T. PRESTON GILLESPIE, JR.
Vice President
Oconee Nuclear Station

Subject: Duke Energy Carolinas, LLC
Oconee Nuclear Station, Units 1, 2 and 3
Docket Number 50-269, 50-270 and 50-287;
Response to Request for Additional Information Regarding License Amendment
Request to Change Technical Specification Surveillance Requirement
Frequencies to Support 24-Month Fuel Cycles
License Amendment Request (LAR) No. 2010-001, Supplement 3

Duke Energy Response to NRC Request for Additional Information

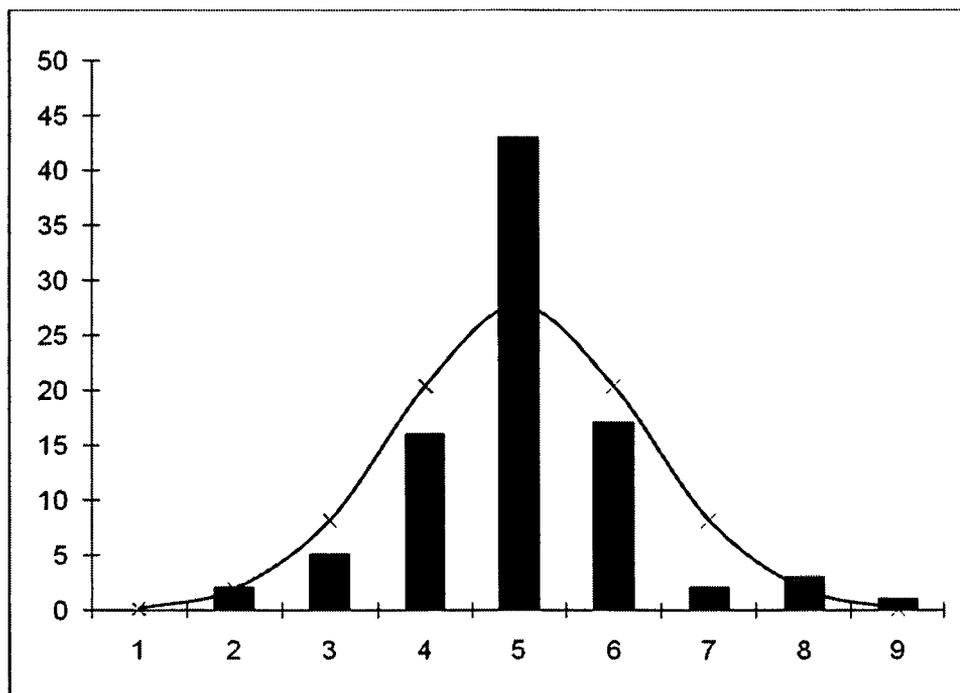
- c. Page 24: Please provide the definition and derivation of the normality adjustment factor (NAF) — including relevant source material and tables.

Duke Energy Response to RAI 8(2)c

The normality adjustment factor is a multiplier whose magnitude is determined iteratively in order to increase the standard deviation of the sample data such that a minimum of 97.5% of the data is within the final tolerance interval established. This multiplier produces a normal distribution model for the drift, which shows adequate data population from the final data set within the $\pm 2\sigma$ bands of the model.

The term is an invented term based on the use of coverage analysis as discussed in EPRI TR-103335-RI, "Guidelines for Instrument Calibration Extension/Reduction Statistical Analysis of Instrument Calibration Data", Final Report, October 1998 (Reference 8.1.2 of OSC-9719). The concept of coverage analysis is discussed in Section C.5 of the EPRI document and stems from the fact that instrument calibration data often has such a high kurtosis (i.e.; a high centered peak distribution) that the data will fail a normality test. The coverage analysis involves the use of a histogram of the data set, overlaid with the equivalent probability distribution curve for the normal distribution, based on the data sample's mean and standard deviation. Visual

examination of the plot is used, and the kurtosis is analyzed to determine if the distribution of the data is near normal. If the data is near normal, then a normal distribution model which adequately covers the set of drift data as observed is derived using the NAF. This normal distribution is then used as the model for the drift of the component or loop. Coverage analysis is discussed in detail in Section 4.8.3.3 of OSC-9719.

Instrument drift calculation OSC-9809 is an example where a NAF was applied to the drift data. Below is the histogram for this data set indicating the high kurtosis and near normal distribution of the data. This result is typical for those instrument loops where the final data set failed the normality test and therefore supports the use of coverage analysis as described in the EPRI document.
